ALPINE CITY PLANNING COMMISSION MEETING

SUBJECT: Retaining Wall Exception

To: Alpine City Planning Commission
From: Jed Muhlestein, P.E. *JM*
City Engineer
Date: June 6, 2018
Subject: Retaining Wall Exception Request – Pratt Residence
663 West Ranch Circle

Subject: **Planning and Zoning Review**
The Ridge at Alpine PRD Preliminary Plan
Approximately 1100 North Grove Drive – 72 lots on 189.5 acres

DRAWING TITLE		PROJECT NAME	DATE
RETAINING WALLS		PRATT RESIDENCE	05/04/2018
LOCATION		DRAWN	SCALE
663 W RANCH CIR		JDL	1/2" = 1'
ALPINE, UTAH		CHECKED	SHEET
		FILE NAME:	D-2
		G:\DATA\18096\DWG\18096 BASE.DWG	
NO.	REVISION	DATE

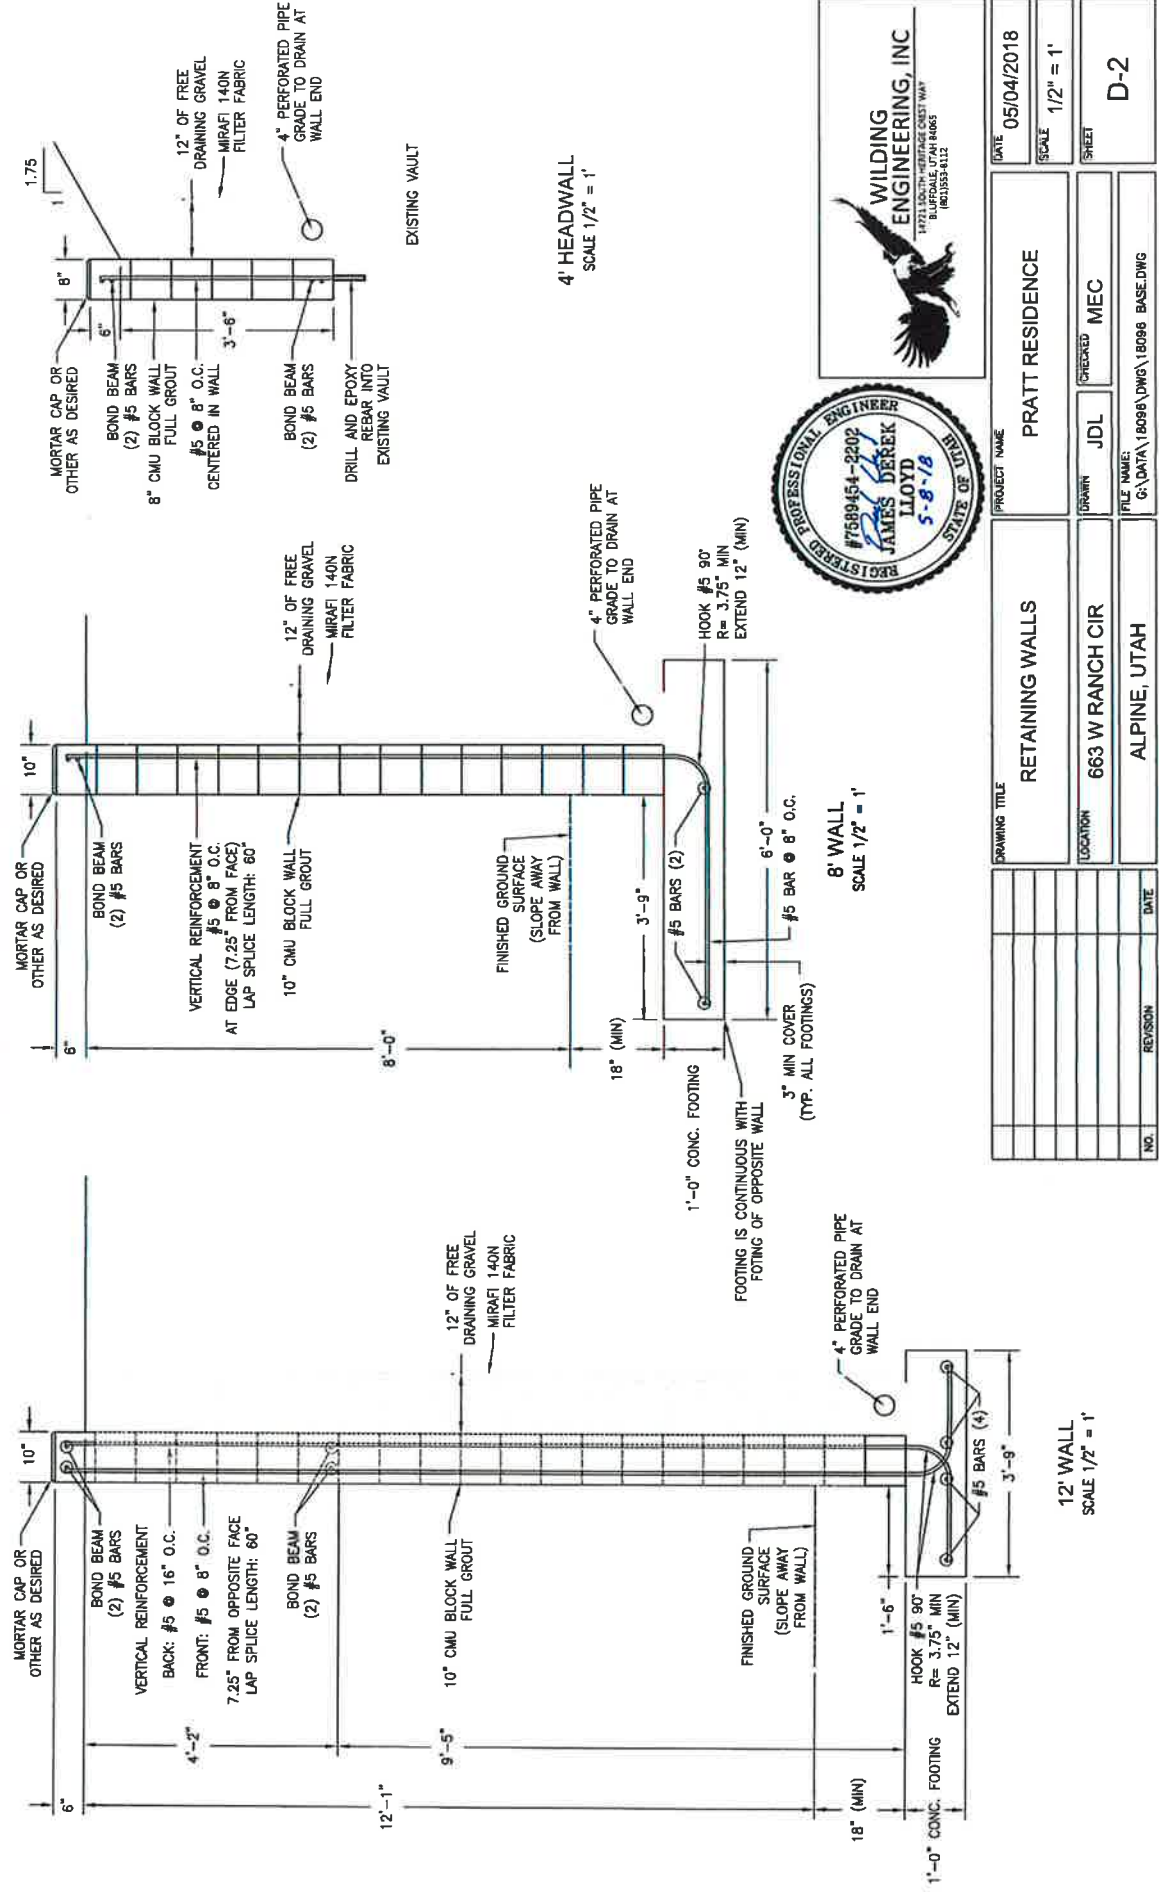
Engineering has reviewed the permit, visited the site, and recommends approval of the concrete retaining wall based on two items. First, calculations have been submitted for a concrete retaining wall design which show it can be safely constructed to that height. These calculations will be independently reviewed prior to issuing a building permit. Second, the wall will not be seen from the nearest public right of way. Even in the current un-landscaped situation, the wall would be hidden from public view. See attached pictures.

**VIEW FROM RANCH CIRCLE
LOOKING SOUTH EAST**

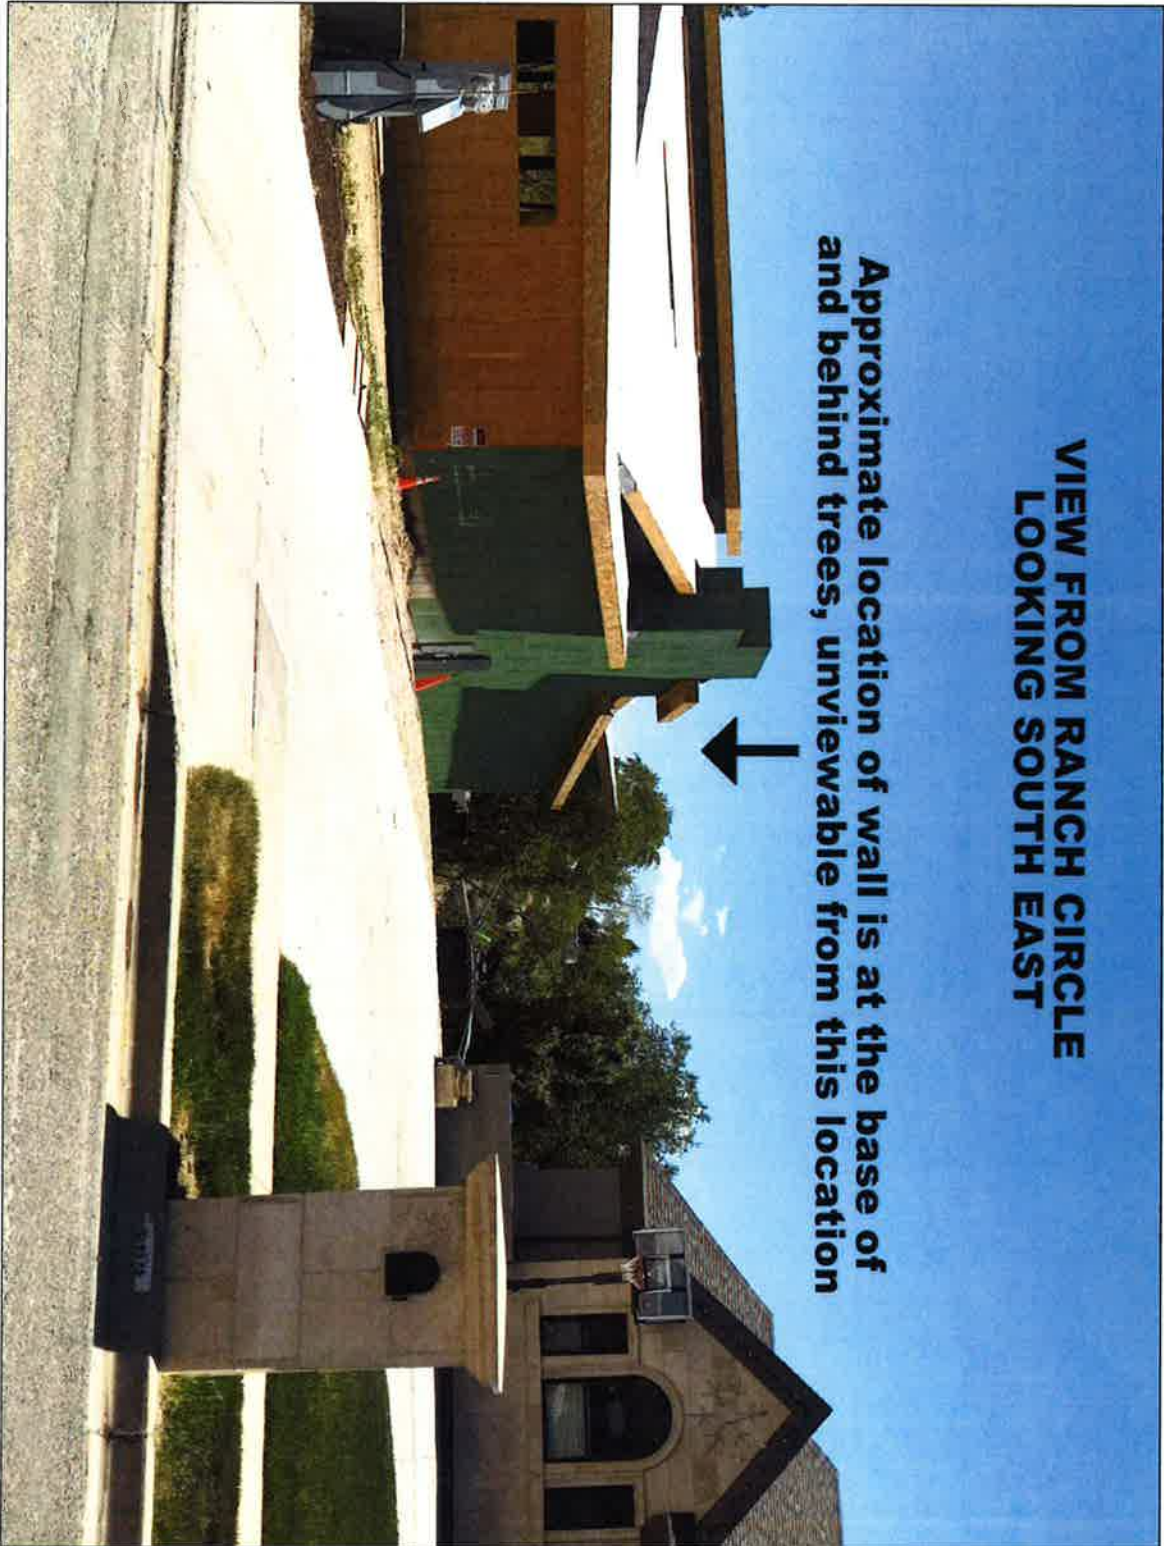
**Approximate location of wall is at the base of
and behind trees, unviewable from this location**

**VIEW FROM RANCH CIRCLE
LOOKING SOUTH WEST**

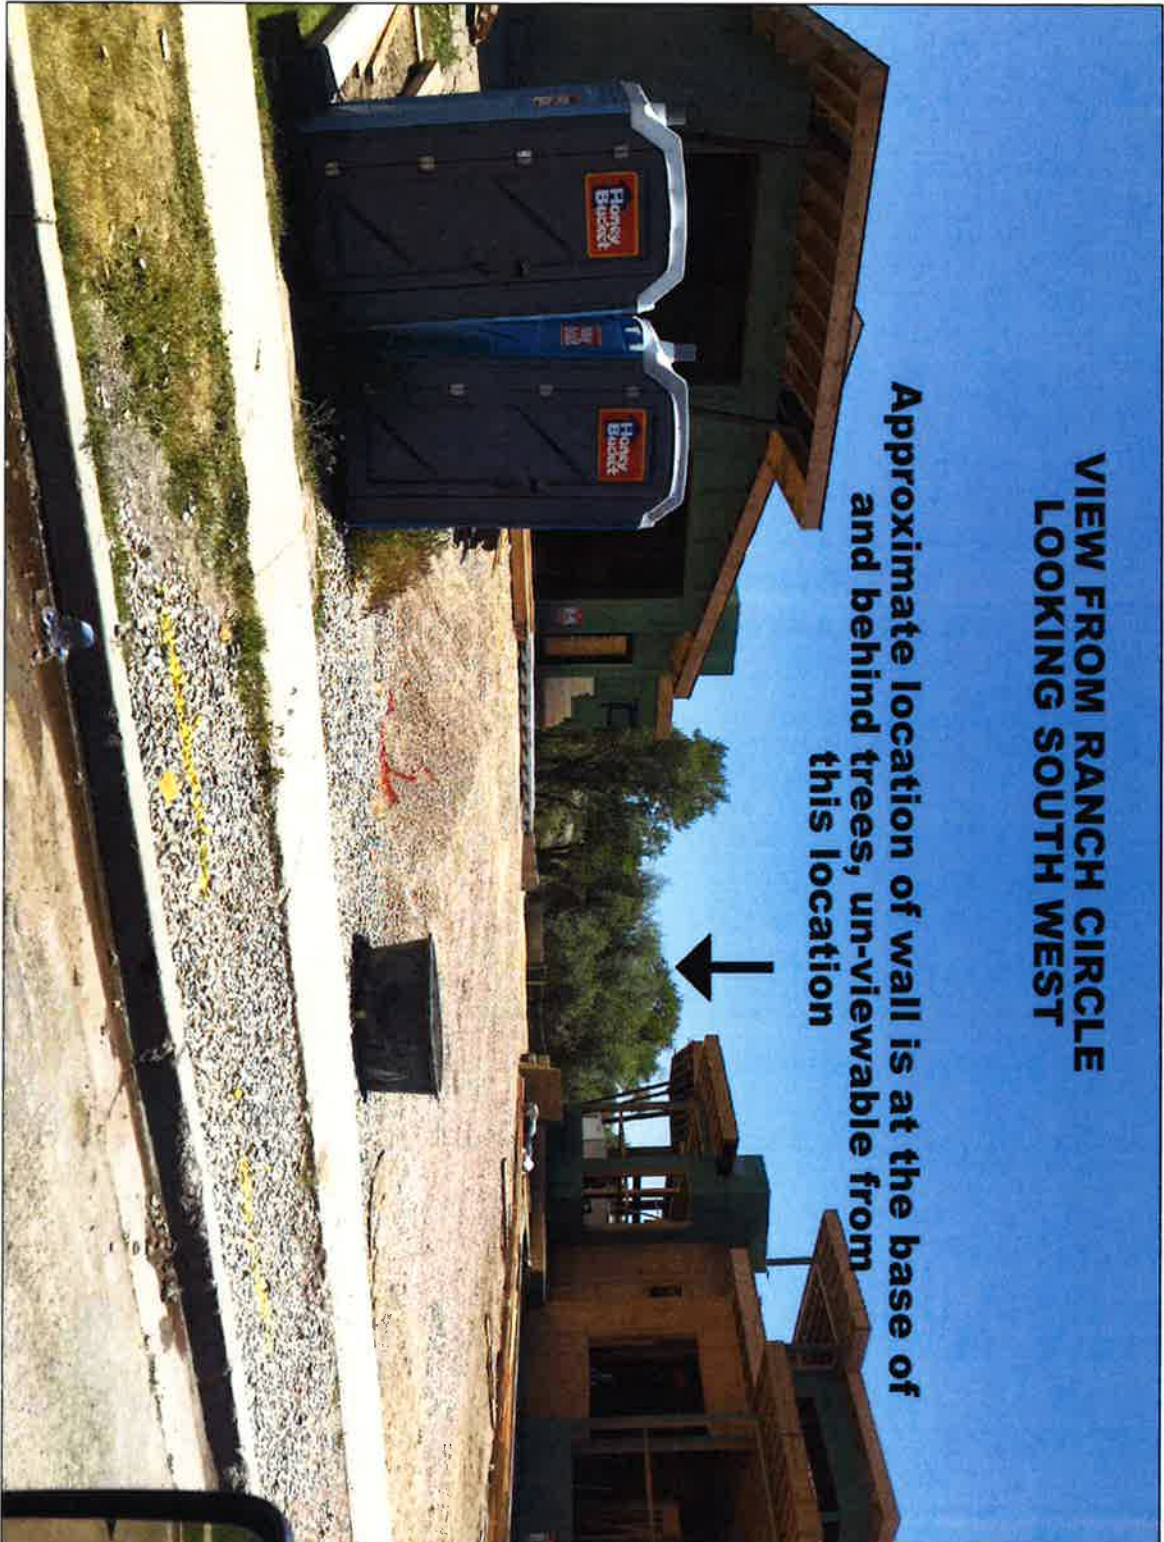
**Approximate location of wall is at the base of
and behind trees, un-viewable from
this location**
